# **Shire of Murray Town Planning Scheme No. 4, Amendment 108**

**Report and recommendations  
of the Environmental Protection Authority**

**Environmental Protection Authority  
Perth, Western Australia  
Bulletin 890  
May 1998**

Figure 2. Subdivision guide plan.

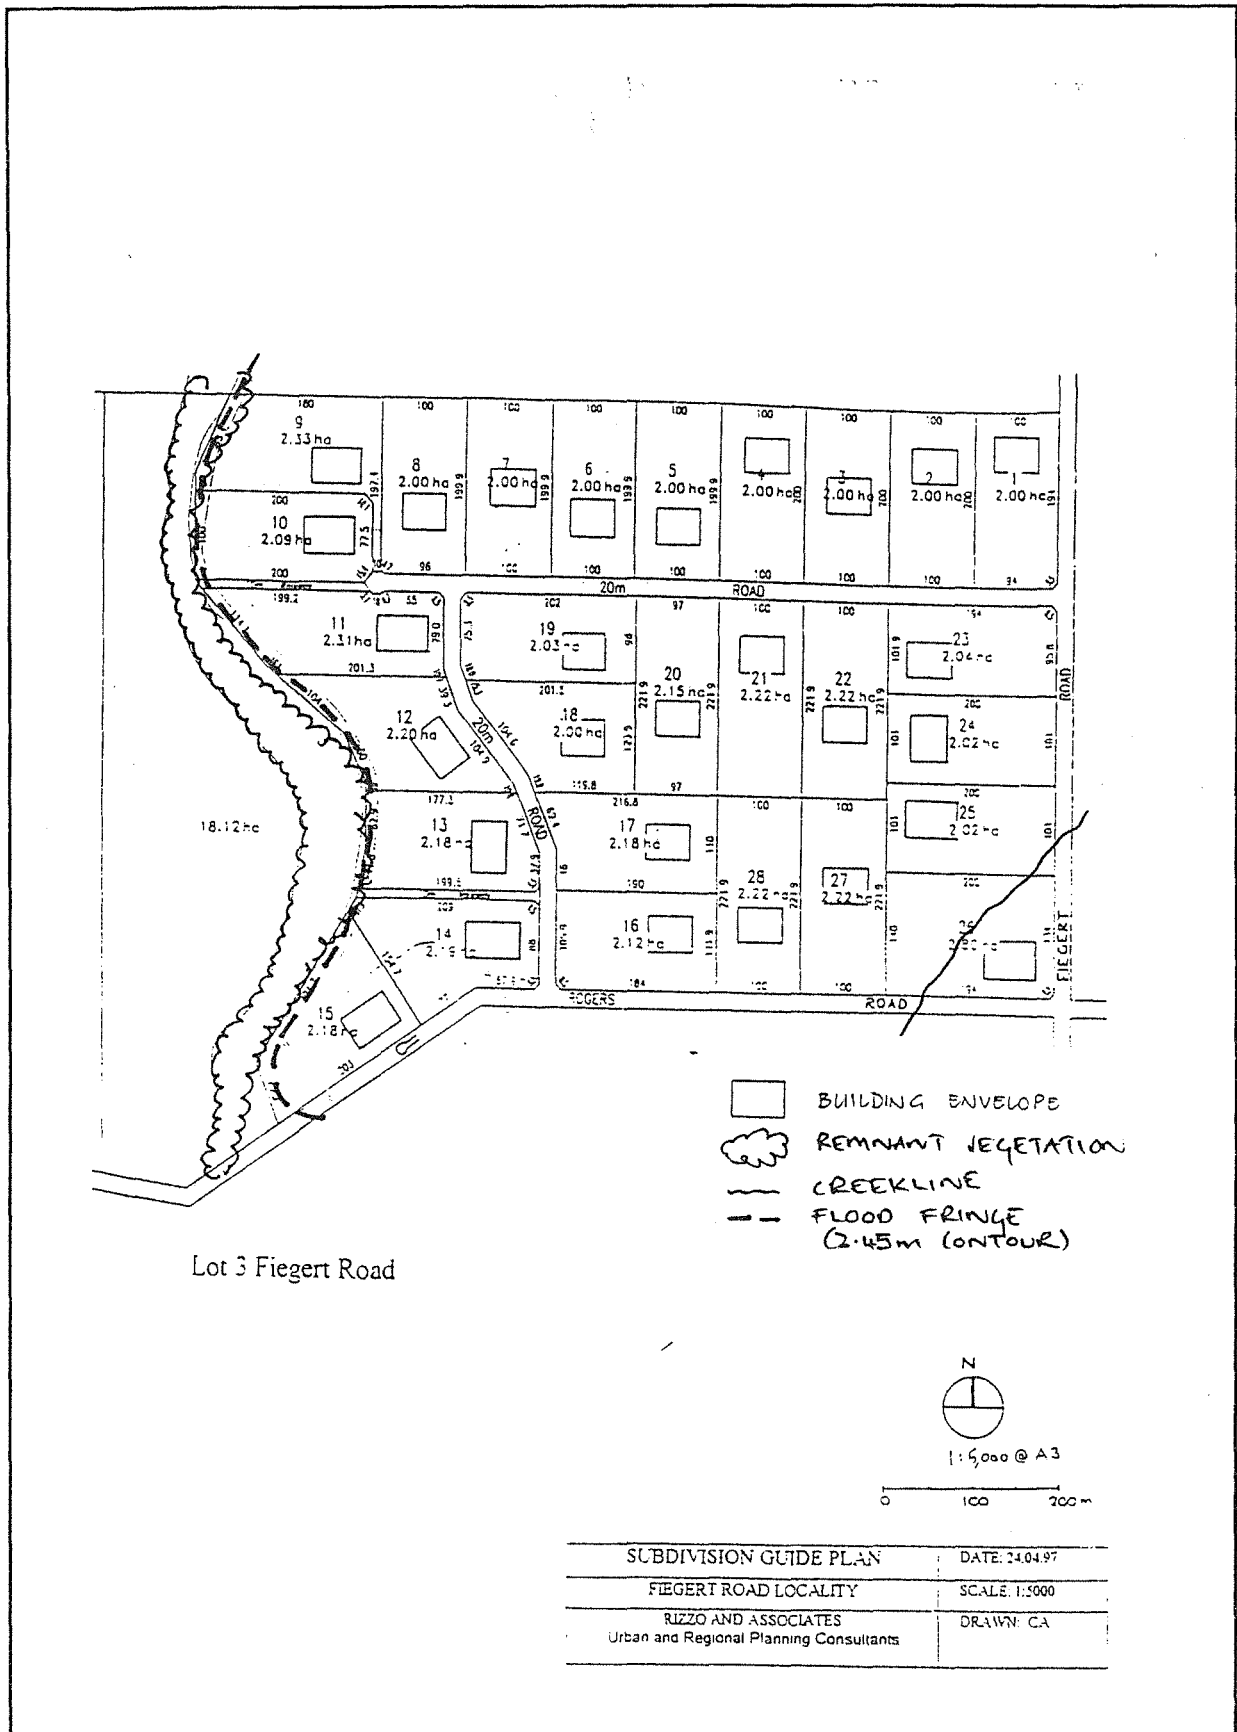
The Subdivision Guide Plan (Figure 2) indicates that only one lot is affected by the seasonal watercourse and there are existing buildings on the property.

The EPA policy for the minimum buffer width for a seasonally flowing watercourse is 30m (EPA, 1997b). The proposed subdivision guide plan indicates that this buffer requirement can be met, as the building envelope for Lot 26 is greater than 30 metres from the watercourse. There is no remnant riparian vegetation along the water course, however, it is recommended that the buffer area be rehabilitated and revegetated with local species.

The Serpentine River Flood Study (Water Authority of Western Australia, 1991) indicates that some land within the amendment area is within the potential 1 in 100 year flood fringe. Areas below the 2.5 metre contour (see Figure 2) may be flooded during a 1 in 100 year flood event, however the effected lots are only those that abut the proposed foreshore reserve. The building envelopes of the effected lots should be situated above the 3 metre contour to avoid flooding in a 1 in 100 year storm event.

2-2 A foreshore reserve shall be provided by the subdivider of Lot 3 in accordance with the subdivision guide plan in attachment 1, except that the foreshore reserve shall be extended where necessary so that it has a minimum width of 50 metres from the furthest extent of the wetland vegetation.
